Downtown West

Amendments to the 2014 Diridon Station
Area Plan

October 7, 2020

Downtown West Overview of Diridon Station Area Plan (DSAP) Amendments

FIGURE 3-4-1.1 : PROPOSED STREET TYPOLOGIES

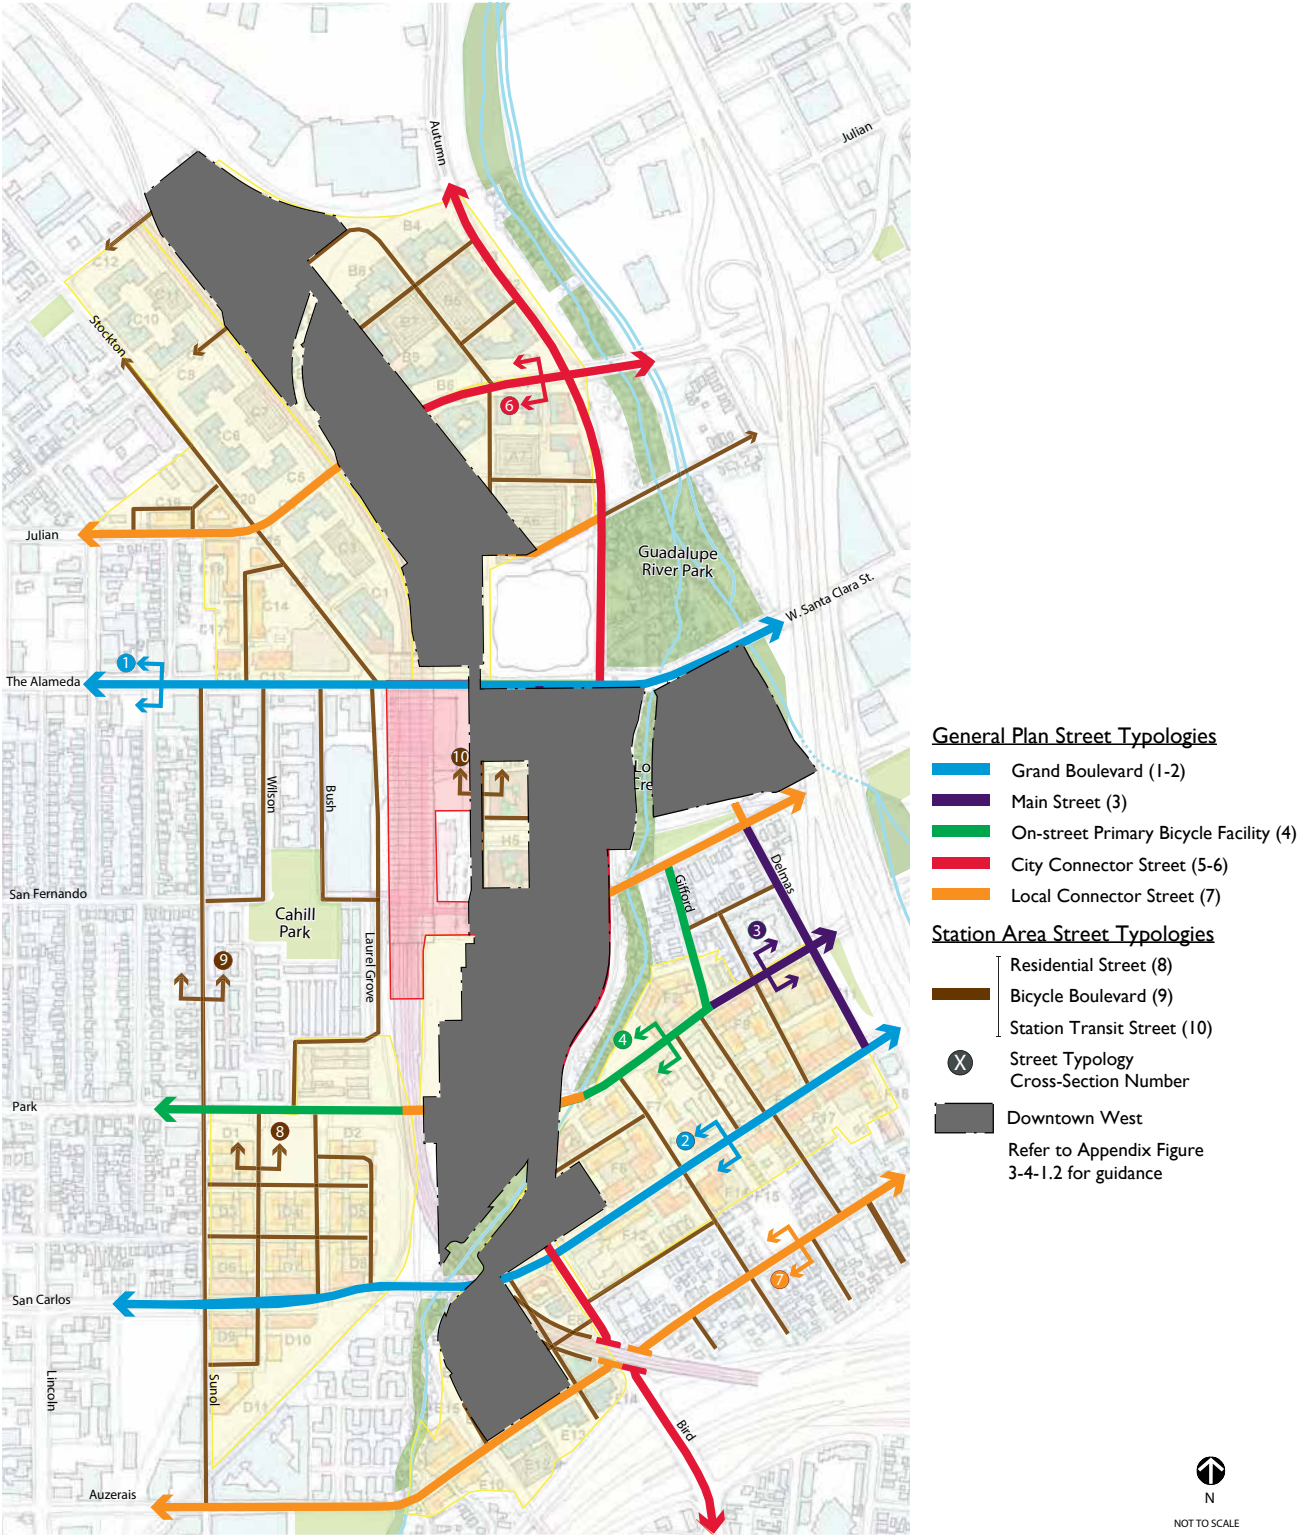
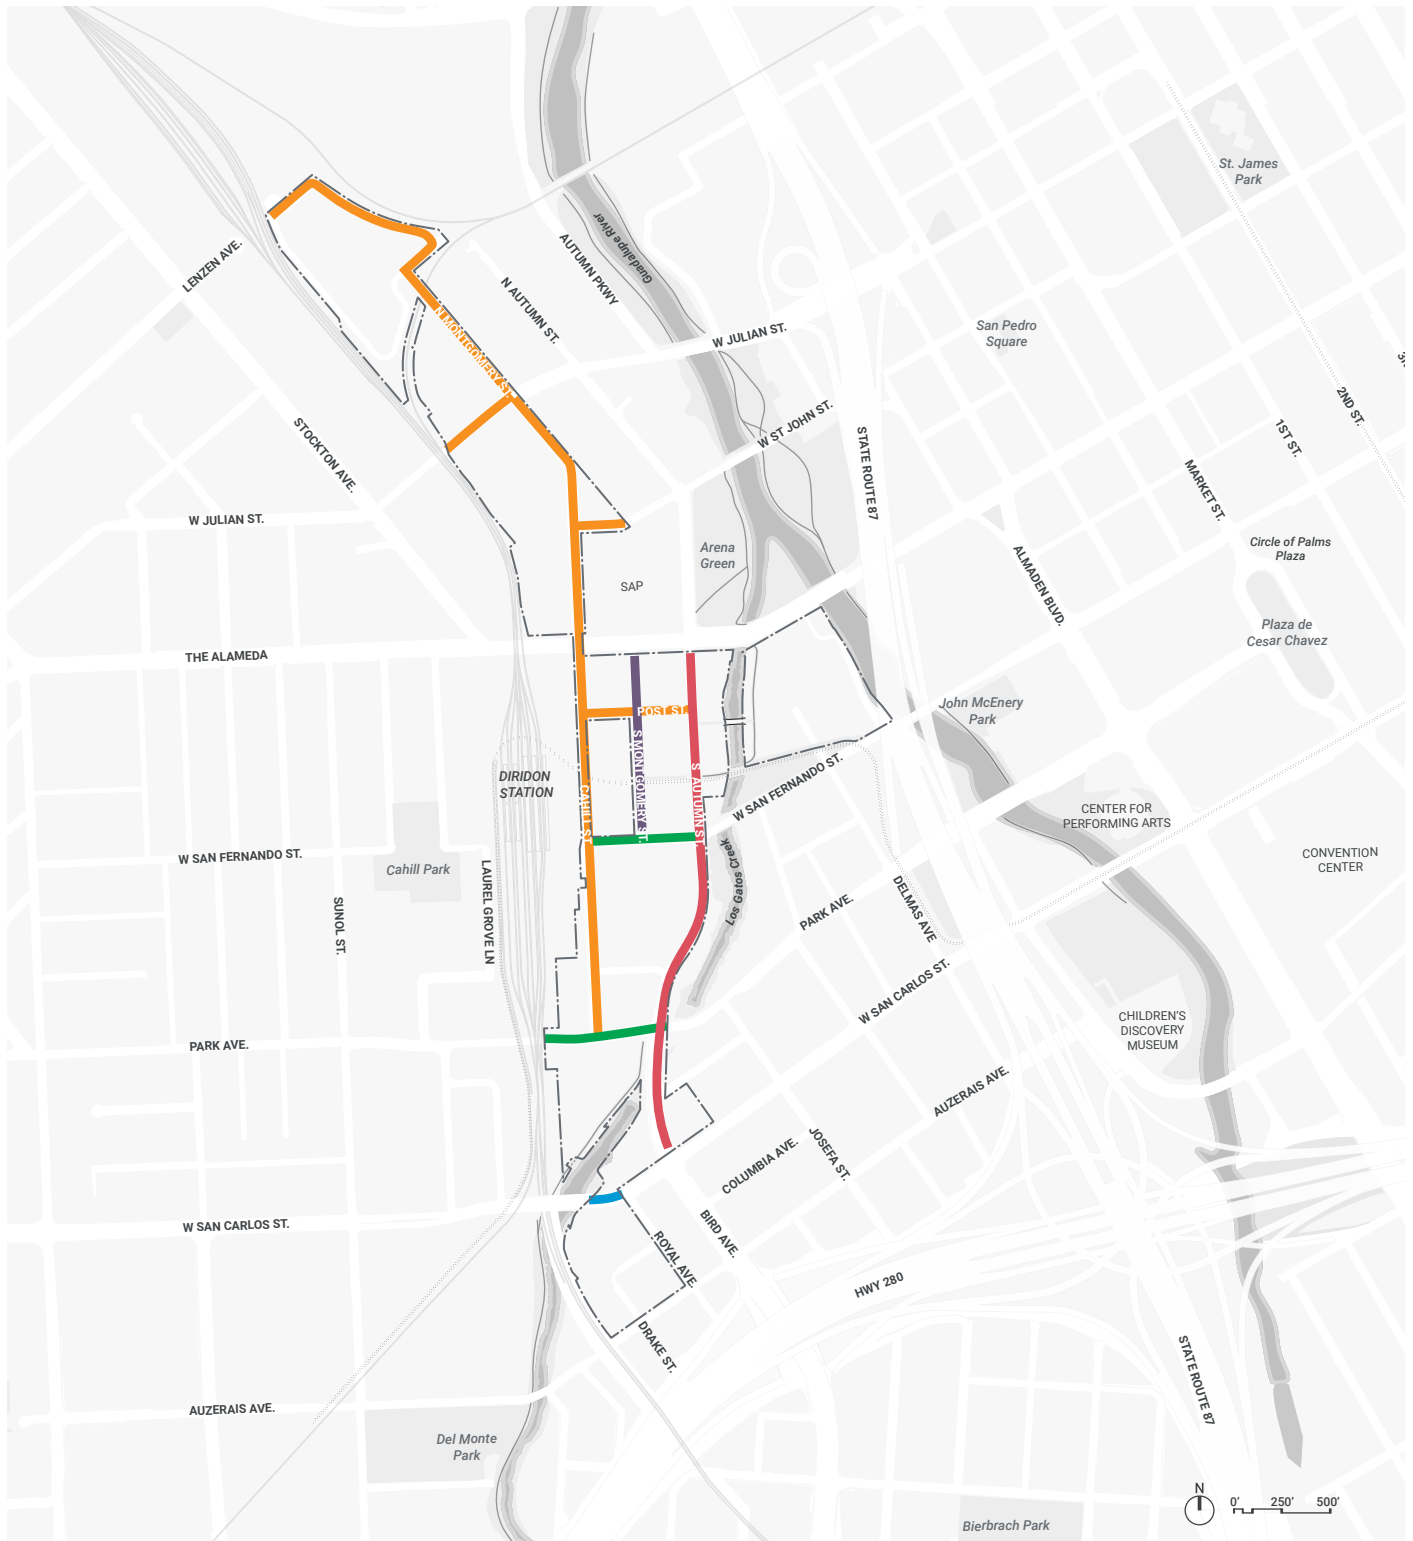
Streetscapes (Section 3.4)	<ul style="list-style-type: none"> • Revise street typologies to be consistent with General Plan and Downtown West. Requires text and figure amendments. • Figure 3-4-1 should be amended to reflect Downtown West. The text describing the street typologies should be further refined to clarify that street design is governed by the Complete Streets Standards and Guidelines, DWDSG and VTM, and the figures of the cross-sections (Figures 3-4-2 - 3-4-6) are illustrative.
Final Plan Maximum Build Out (Chapter 4)	<ul style="list-style-type: none"> • Include a statement indicating that: (1) this section has no regulatory effect; (2) Downtown West is not subject to this chapter; and (3) remove reference to materials that have been removed earlier, such as the Test Fit • Discussion with the City is required to determine appropriate treatment of figures and assumptions in Chapter 4 (maximum buildout capacity).

3-4-1	Proposed Street Typologies	Amend
3-4-2	Grand Boulevards	No Change
3-4-3	Main Street and On-Street Primary Bicycle Facilities	No Change
3-4-4	City Connector Streets	No Change
3-4-5	Local Connector Street	No Change
3-4-6	Residential Street, Bicycle Boulevard and Station Transit Streets	No Change
3-4-7	Underpasses	Amend
4-1-1	Northern Zone - Building Heights	Remove
4-1-2	Northern Zone - Maximum Build-out Totals by Block	Remove
4-1-3	Central Zone - Building Heights	Remove
4-1-4	Central Zone - Maximum Build-out Totals by Block	Remove
4-1-5	Southern Zone - Building Heights	Remove
4-1-6	Southern Zone - Maximum Build-out Totals by Block	Remove
4-1-7	Summary Maximum Build-out Totals	Remove
4-1-8	Opportunity Sites	No Change
4-1-9	FAA and ALUC Flight Path Height Restrictions Map	Amend
4-1-10	FAA and ALUC Flight Path Height Restrictions Map	Remove
4-2-1	Parking Supply Locations	Remove
